THE MARYLAND-NATIONAL CAPITAL PARK AND PLANNING COMMISSION

MEMORANDUM

REVIEW TYPE: Preliminary Plan Application

PROJECT NAME: Poplar Hill

PRELIMINARY PLAN POPLAR HILL

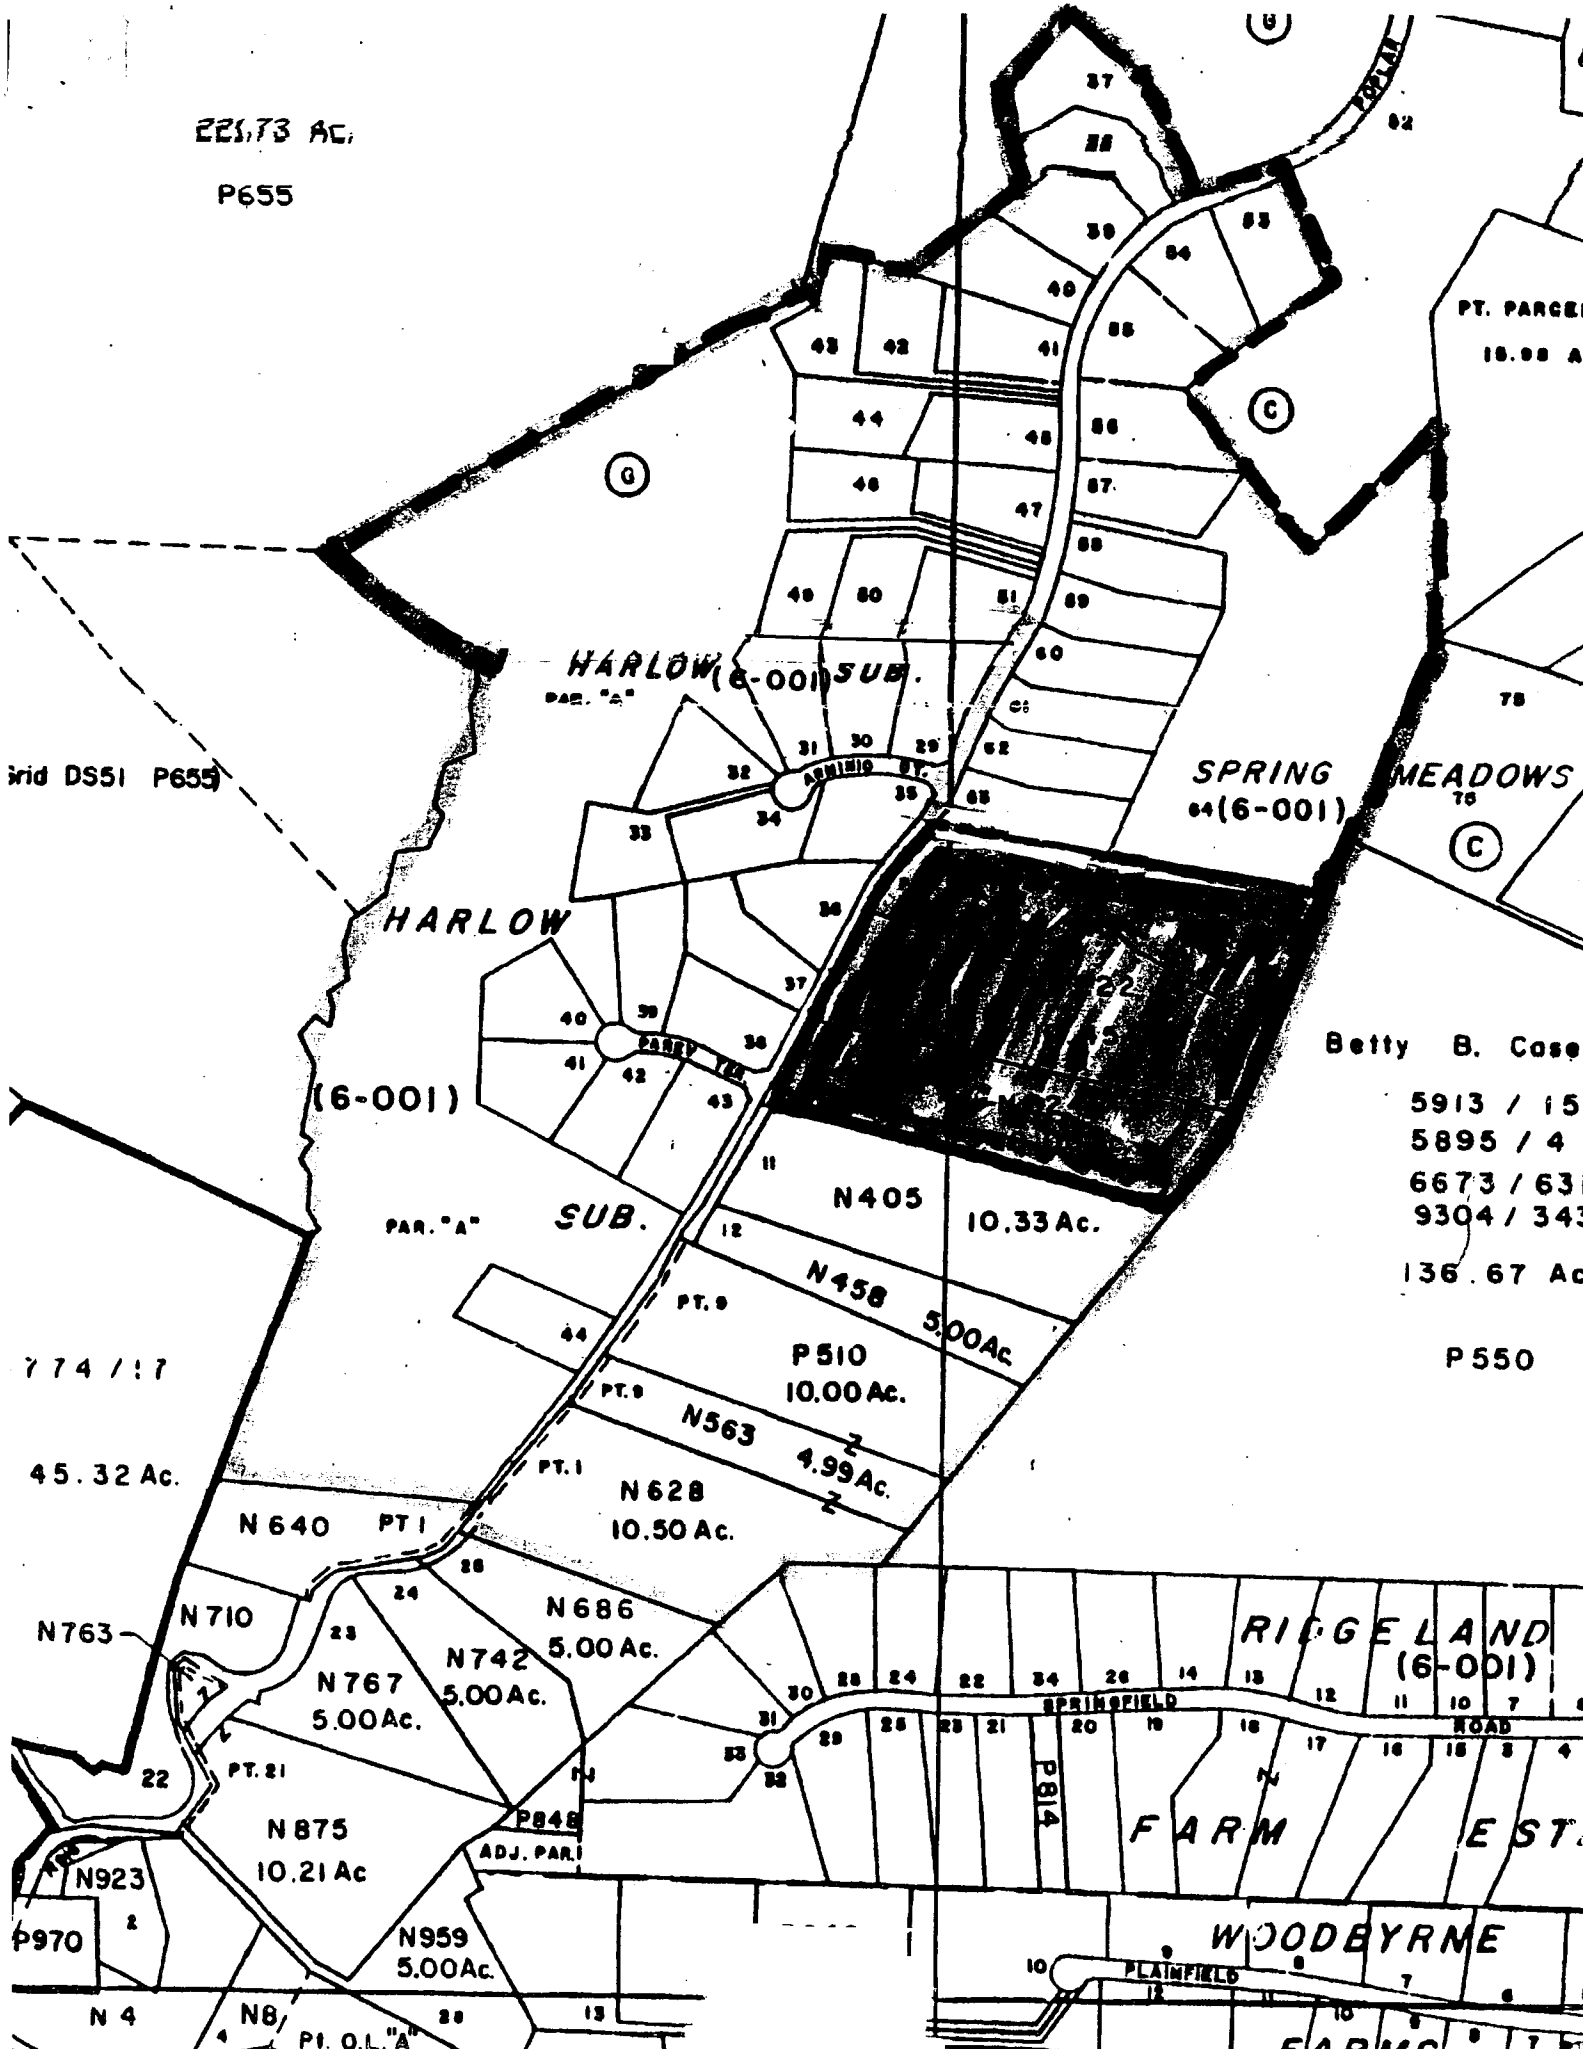
Staff has reviewed the proposed application under the “Resubdivision Criteria” and concludes the application does not conform to the provisions of this section. This application for resubdivision, unlike the other resubdivisions which have occurred in the defined neighborhood, would, in staffs estimation, set a redevelopment precedent for the recorded lots on the east side of Poplar Hill Road. The resulting subdivision creates lots of a pipestem configuration. This lot configuration is not common on the west side or the east side of Poplar Hill Road

The development pattern suggested under this application creates a situation that does not lend itself to a supportable cluster plan. Staff does conclude that the preliminary plan does provide a better open space configuration than did the pre-preliminary application. The applicant’s desire to retain the existing dwelling units does limit the ability to provide useable, contiguous open space. The typical lot pattern that has evolved on the west side of Polar hill Road is that of clustering lots along the road frontage, with the bulk of the property in opens pace. As is demonstrated by the neighborhood location maps, the open space areas are individual parcels and not easements on existing properties. This pattern has served to protect the stream valley by located the residential out of the sensitive areas. The applicants have improved upon the first submission of the pre-preliminary plan by relocating the proposed new lots along the Poplar Hill Road frontage but have not sufficiently proven that the open space areas are readily accessible or useful to the surrounding development
